FTP Project Reference: FTP/2601/04

Application Reference: 260425

St Paul's C of E Junior School, Oxford Road, Wokingham, RG41 2YJ

Full application for the proposed single storey SEND resource base and associated landscaping

Title
EXISTING AND PROPOSED STAFF CAR PARKING LAYOUT

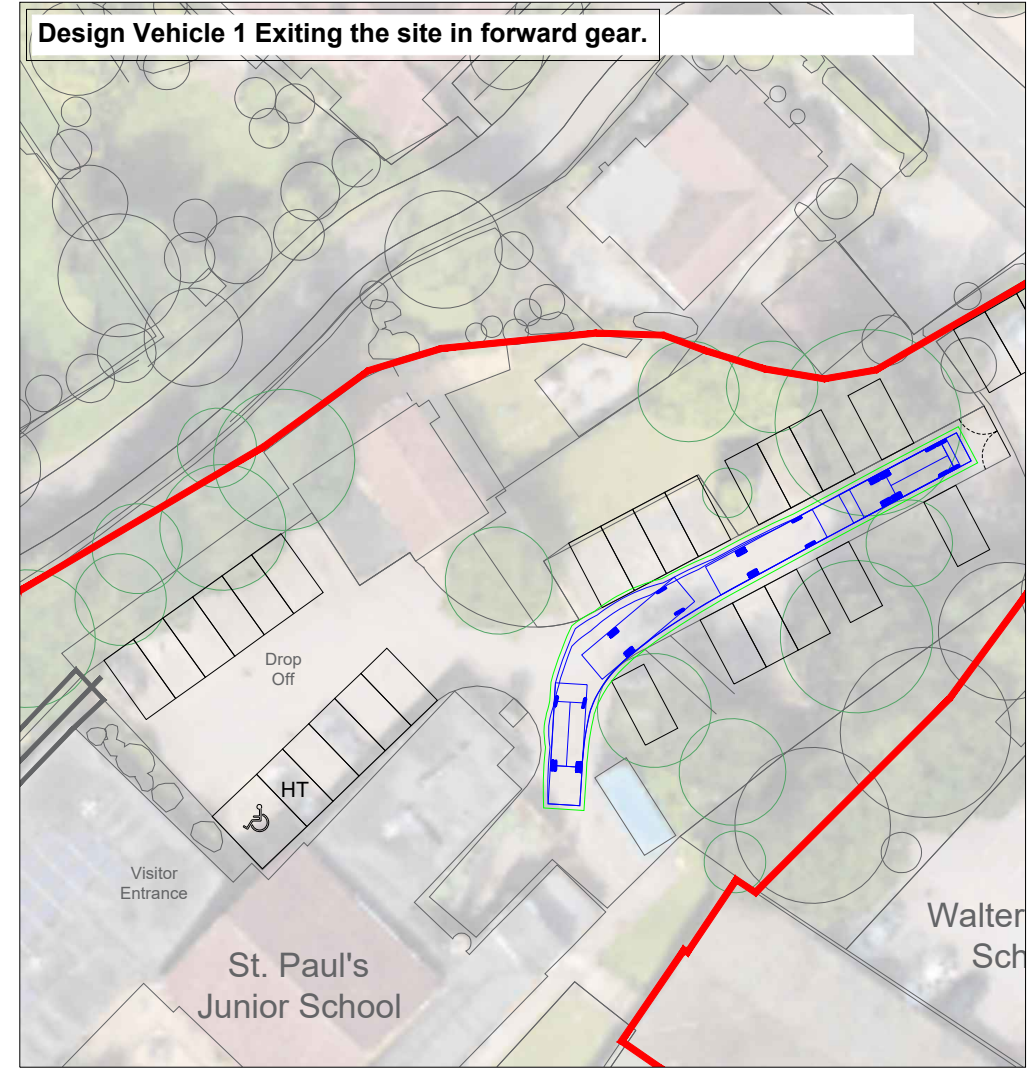
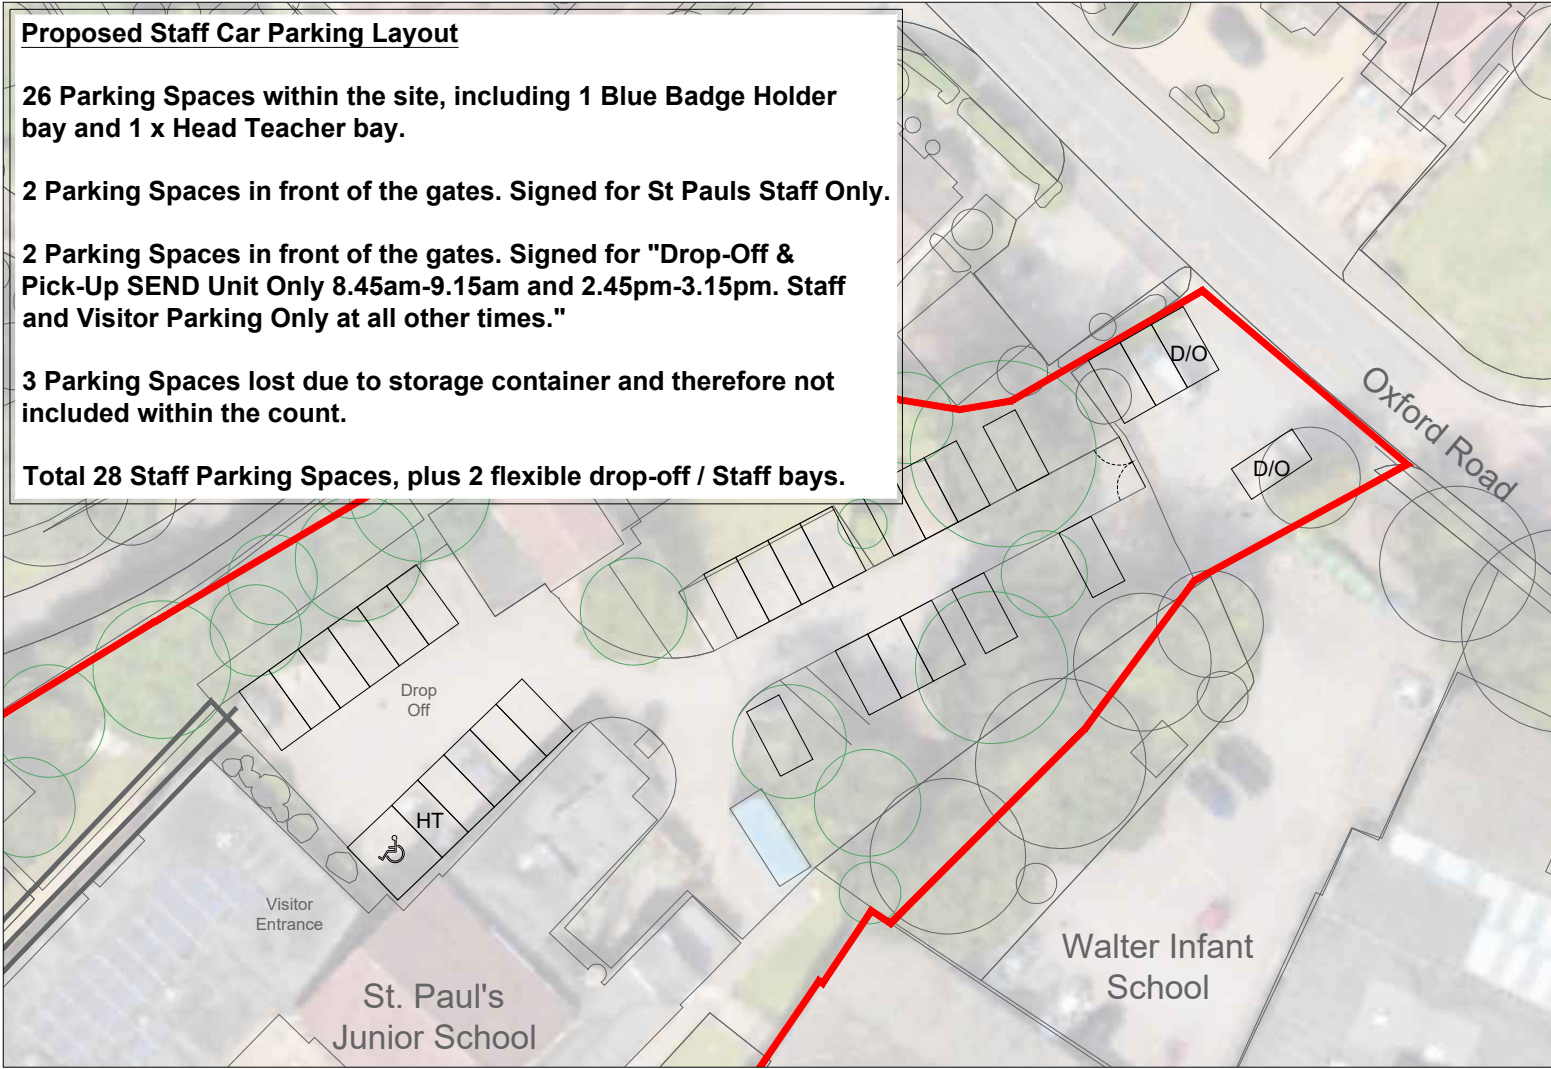
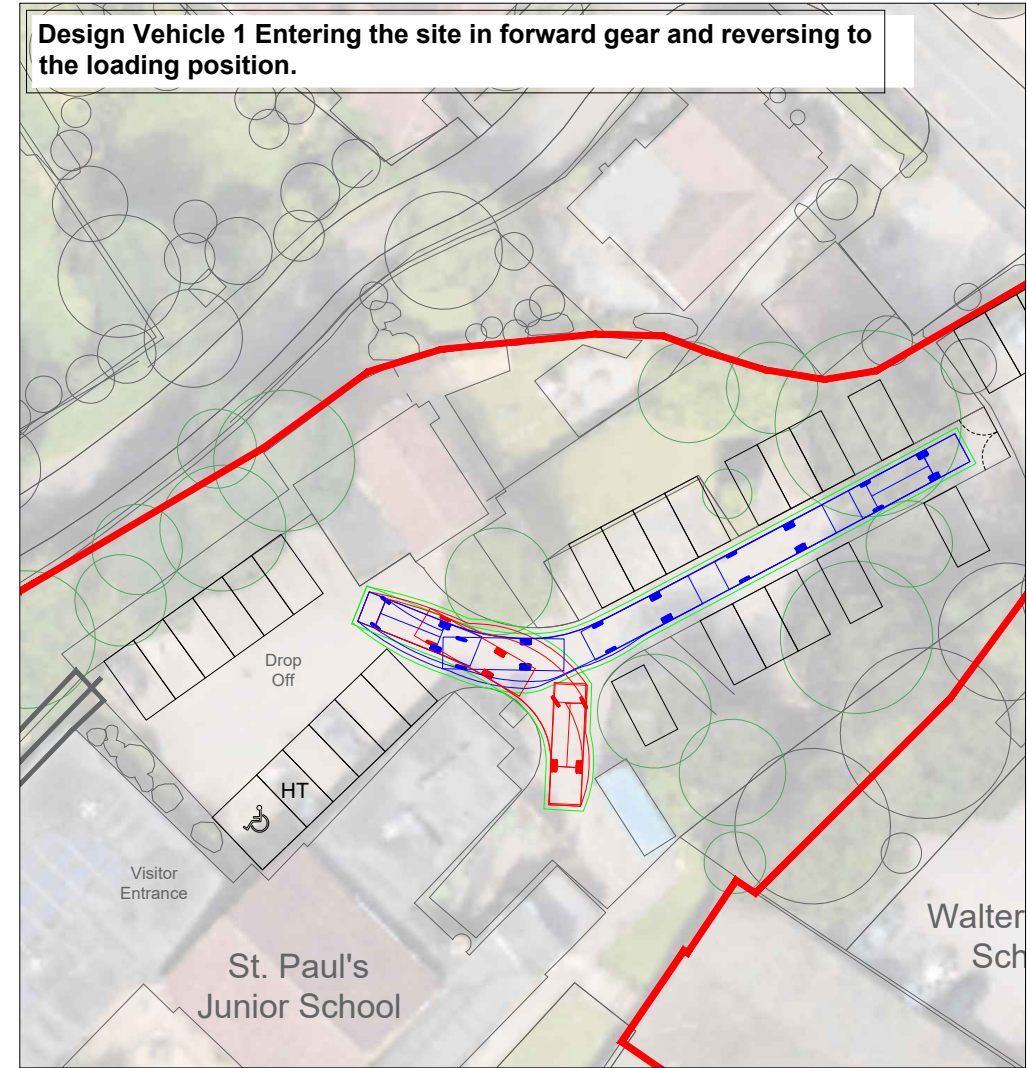
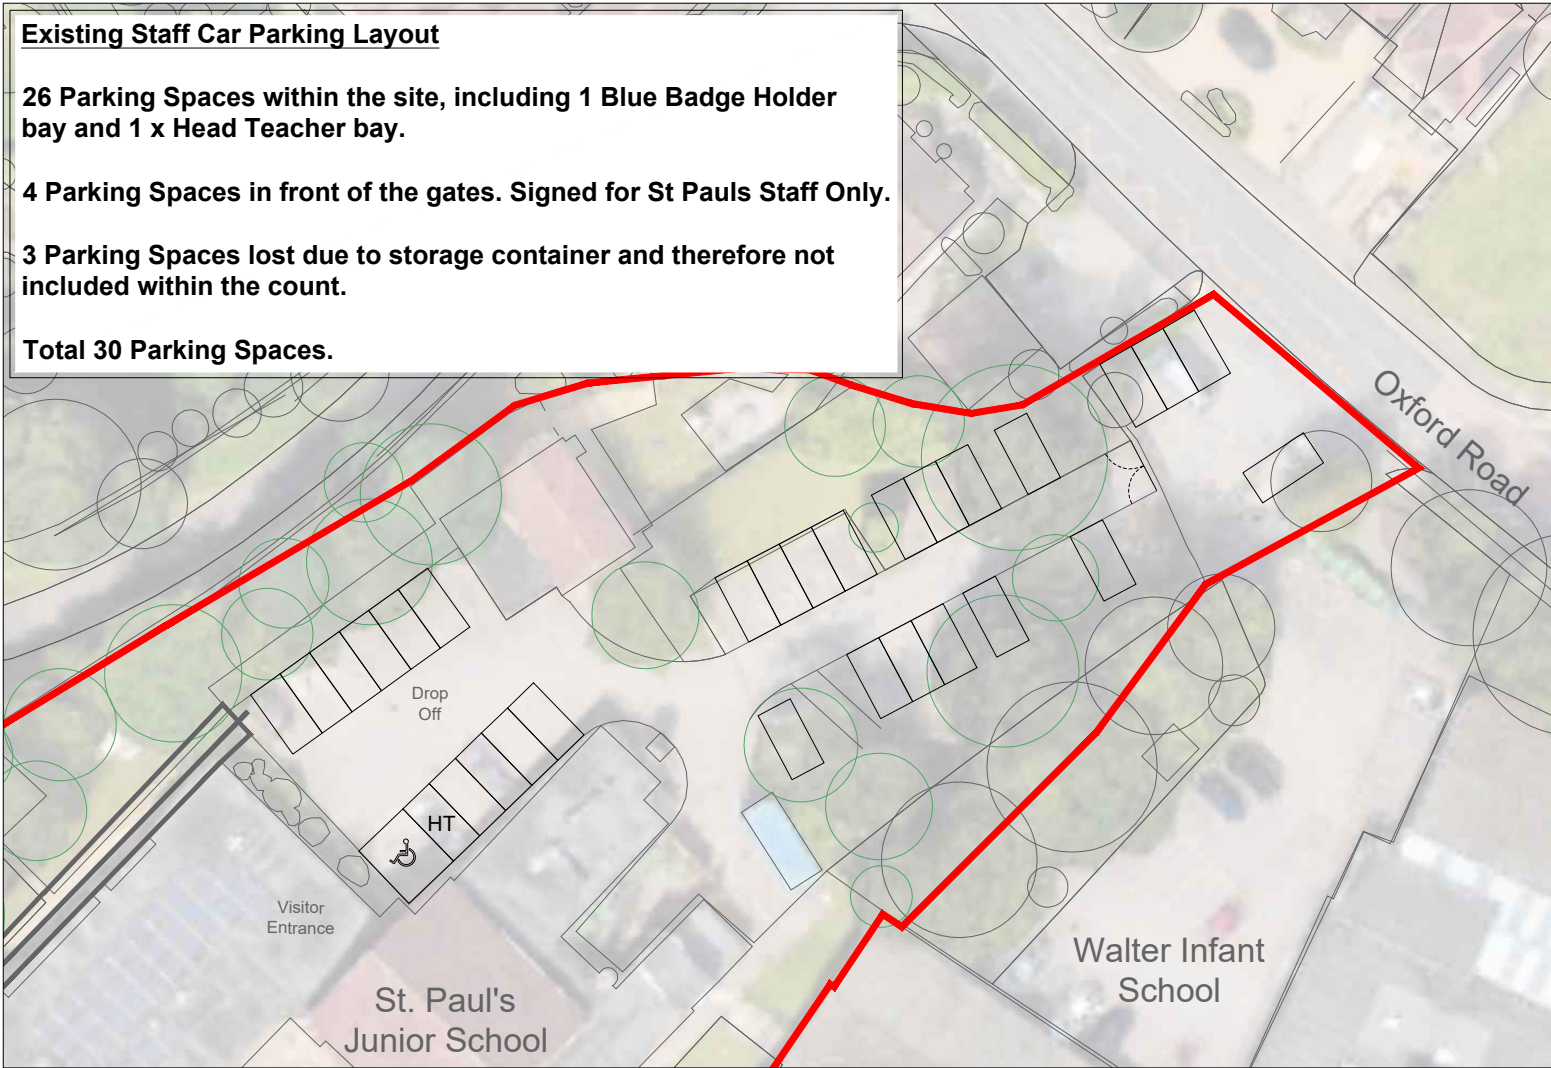
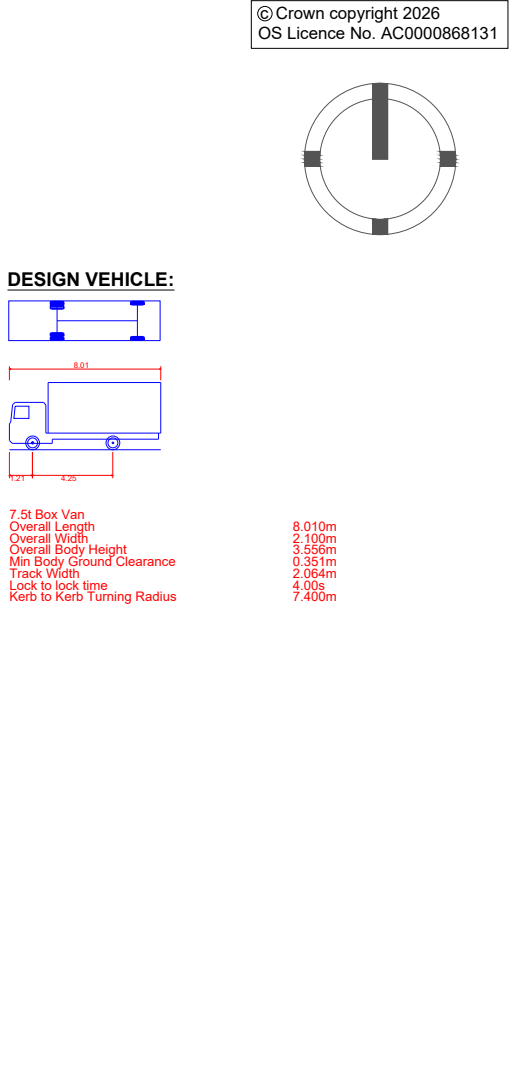
- 1.1 This Technical Note (TN02) has been prepared on behalf of the applicant to respond to comments raised by WBC Highways in relation to the planning application (**260425**) for a new detached single storey SEND unit at **St Paul's C of E Junior School, Oxford Road, Wokingham, RG41 2YJ**.
- 1.2 TNO2 follows on from TN01 dated 7 May 2026, and provides additional information in relation to the existing and proposed on-site parking provision.
- 1.3 A total of 3 site visits were undertaken by FTP on **Thursday 21 May 2026** at **09:20, 11:30** and **13:30** to observe and record the existing parking layout and capacity. The school was operating as normal at the time of the site visit and is considered to be a 'neutral' day.

- 2.1 The plan attached at **Appendix A** shows the existing parking layout as observed and measured on 21.05.2026. The site provides a total of 30 parking spaces, including 1 blue badge holder bay and 1 Head Teacher bay as summarised in **Table 2.1** below.
- 2.2 As shown on the plan at **Appendix A**, the proposals seek to re-allocate 2 bays at the front of the site to as drop-off and pick-up for the SEND unit between 8.45am-9.15am and 2.45pm-3.15pm. The parking bays will remain available during the day for visitors and part-time staff.

- 2.3 The proposals result in a net reduction of 2 staff car parking spaces, through the re-allocation of spaces to provide on-site drop-off and pick-up space for the SEND unit.

2.4 The plan attached at **Appendix A** shows the turning arrangements for a 7.5T (8m) LGV which is the largest vehicle used to regularly service the school from within the site.

- 5.2 This TN includes a parking and turning plan of the existing and proposed car park layouts as requested by WBC and confirms that the proposals result in a net reduction of 2 staff car parking spaces, through the re-allocation of spaces to provide on-site drop-off and pick-up space for the SEND unit.
- 5.3 This TN confirms that a School Travel Plan (STP) will be secured by condition and will include a range of measures and commitments to reduce the number of staff travelling alone by private car and increase the number of staff travelling by sustainable and active travel modes. It is agreed that it is suitable for the STP to be discharged prior to occupation of the development.
- 5.4 It is considered that this TN suitably addresses all comments raised by WBC Highways and the development proposals should therefore be considered acceptable on highway grounds.

STAFF CAR PARKING SURVEY

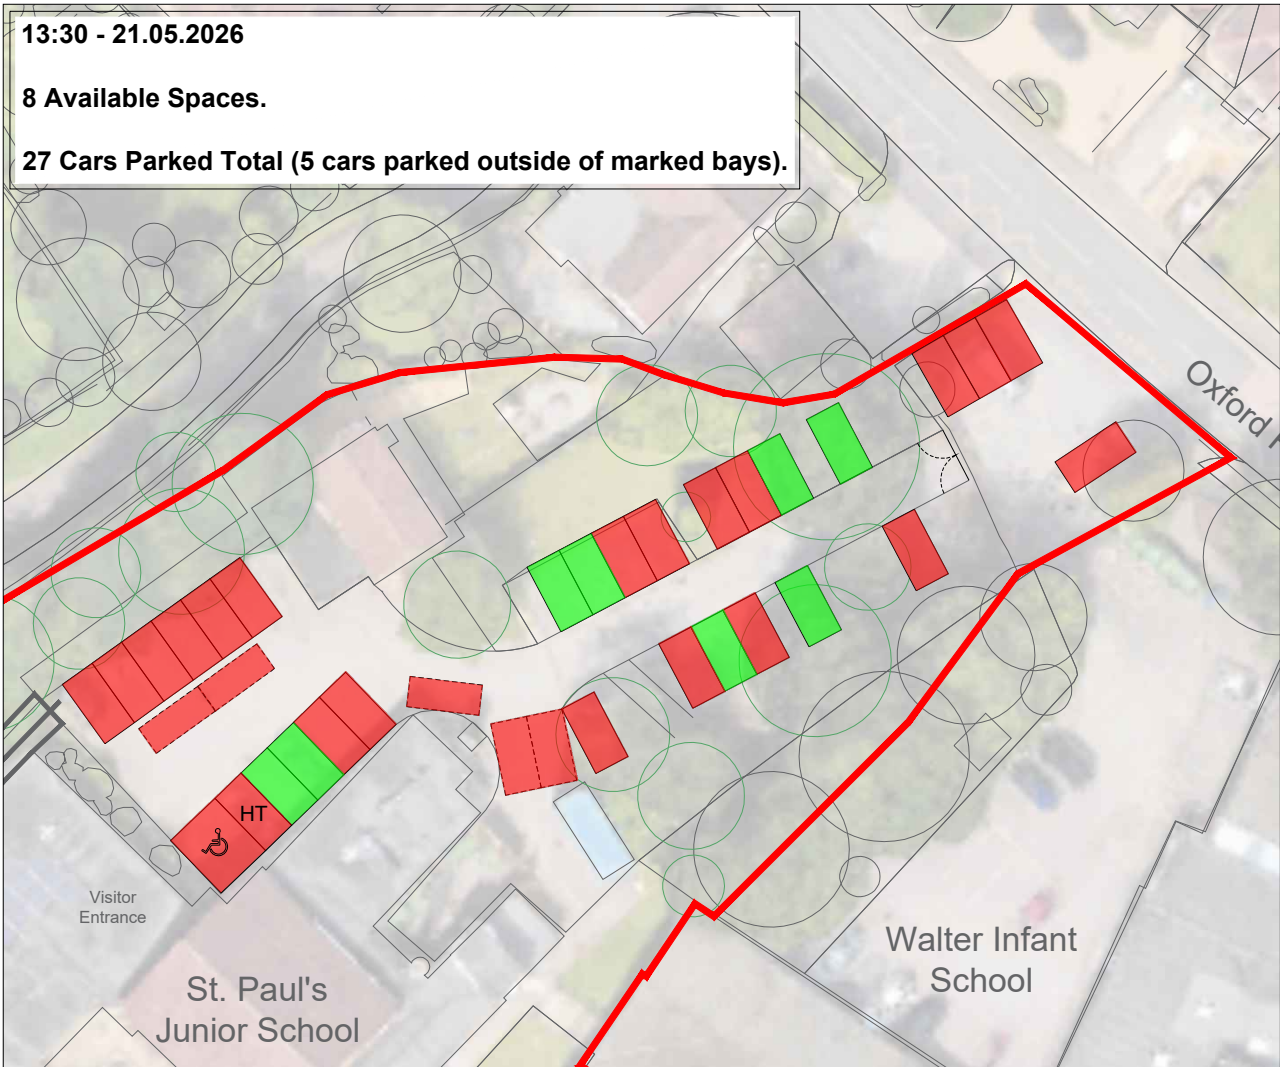
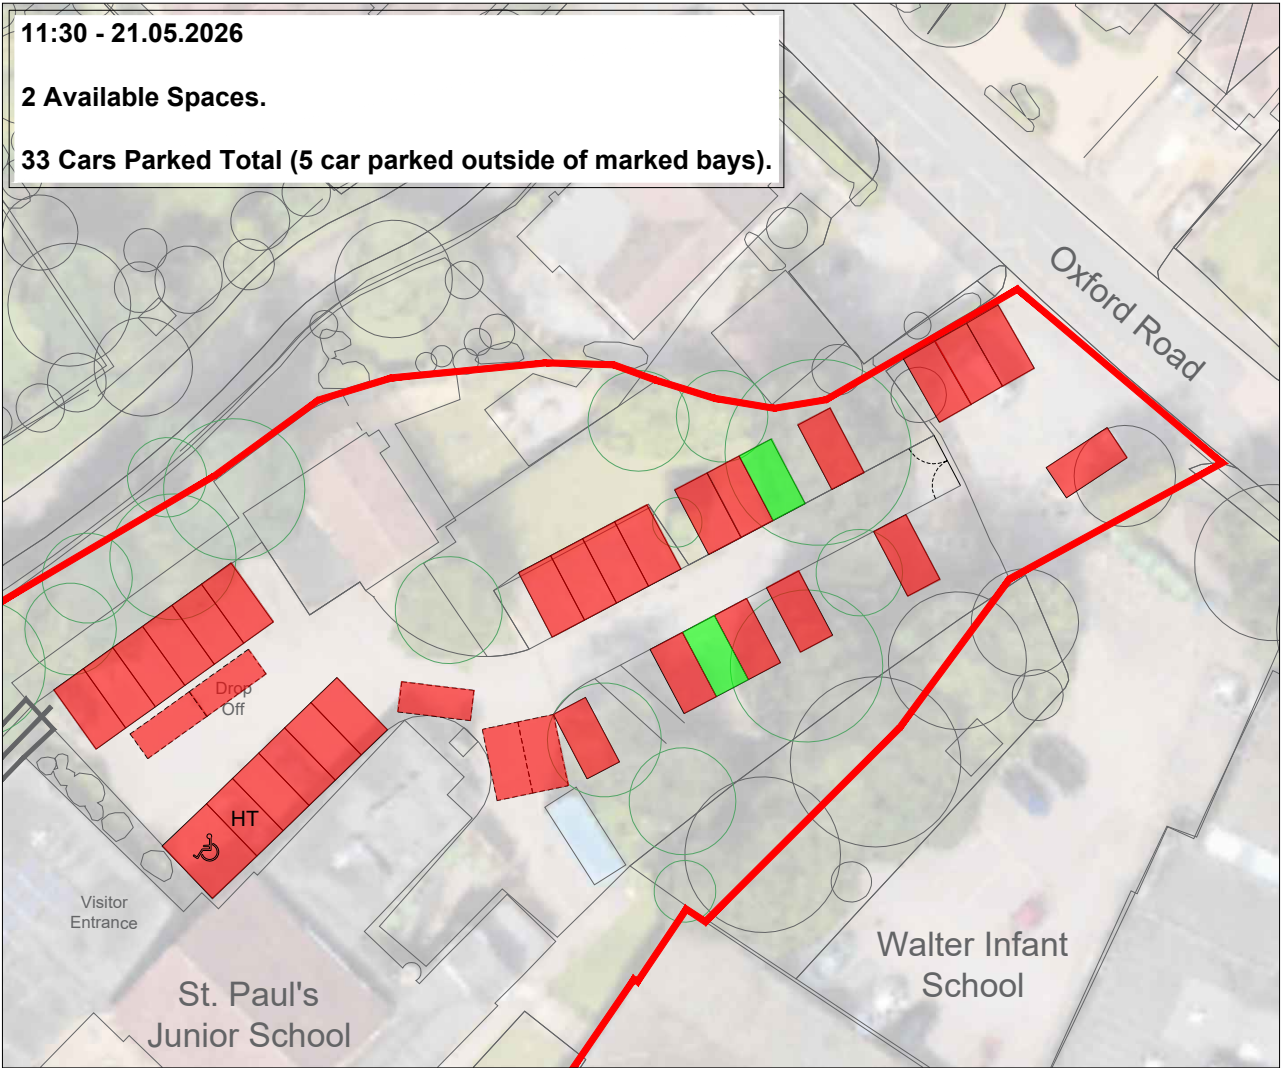
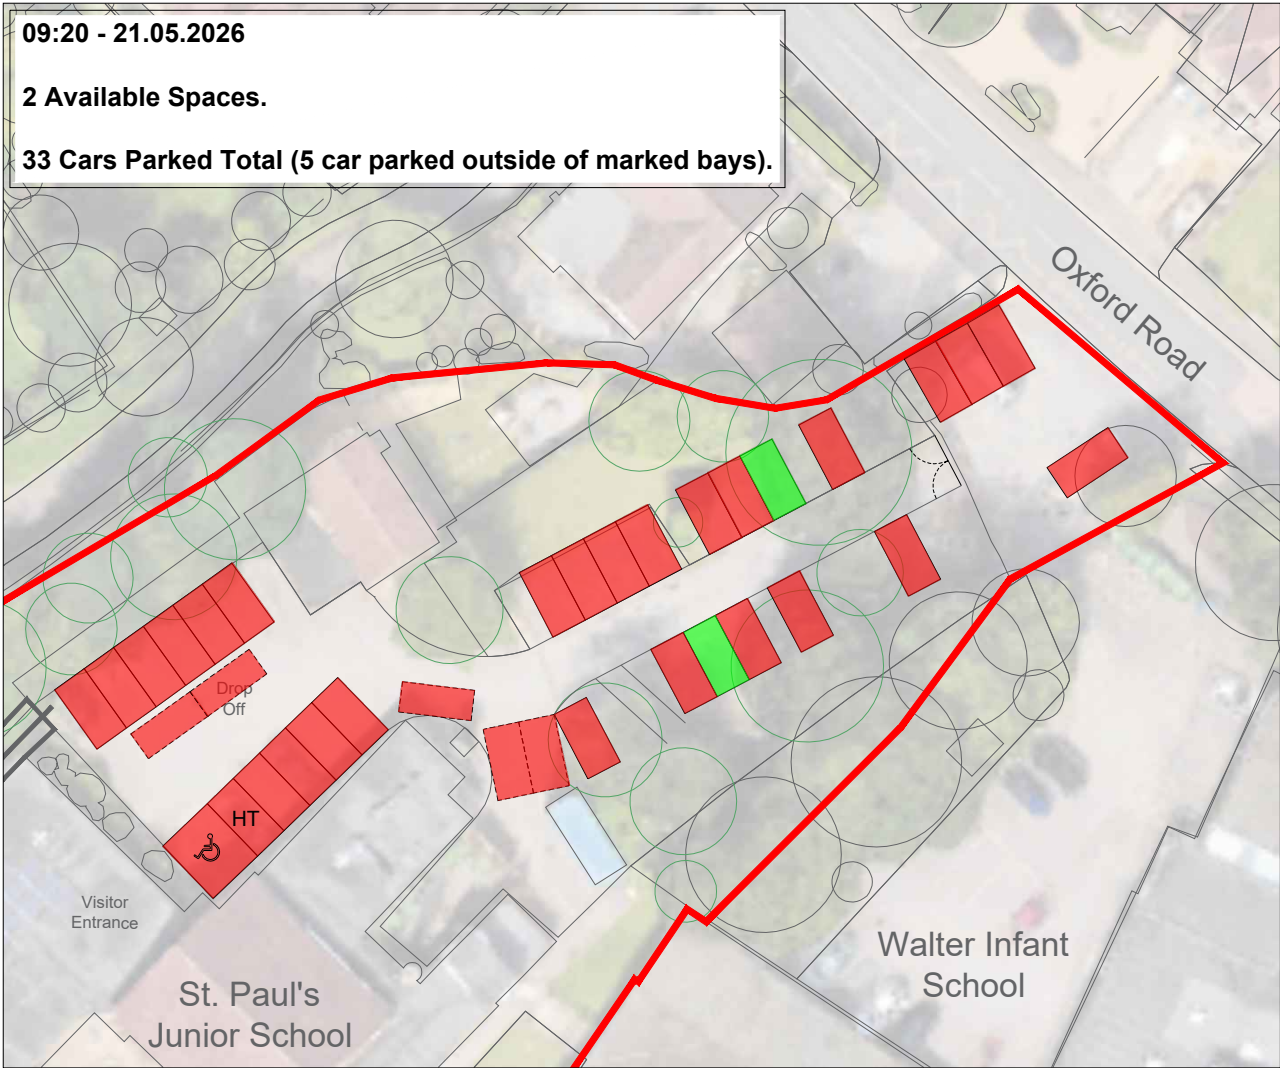
3.3 As detailed within the TS and TN01, the existing car park is operating at capacity, with some available spare capacity during the afternoon period. Vehicles are observed to park outside of marked bays within the main area of the car park, and within the turning area.

2.5 It should be noted that as shown on the parking survey result plans at **Appendix B**, that a total of 5 cars park on-site outside of marked bays which restrict the turning of larger delivery vehicles. When this occurs, the site controller assists the drivers to reverse from the site to Oxford Road.

It is understood that parking outside of marked bays is a daily occurrence. In practice, the informal parking spaces do not cause an issue but do remove the ability for delivery vehicles to turn within the site.

As such, smaller deliveries are undertaken from the entrance gate. Larger vehicles reverse from the site to Oxford Road with assistance from the Site Controller.

Available spaces at 09:20 and 11:30 would only be suitable for smaller cars due to cars not parking efficiently (bays are unmarked in these areas).
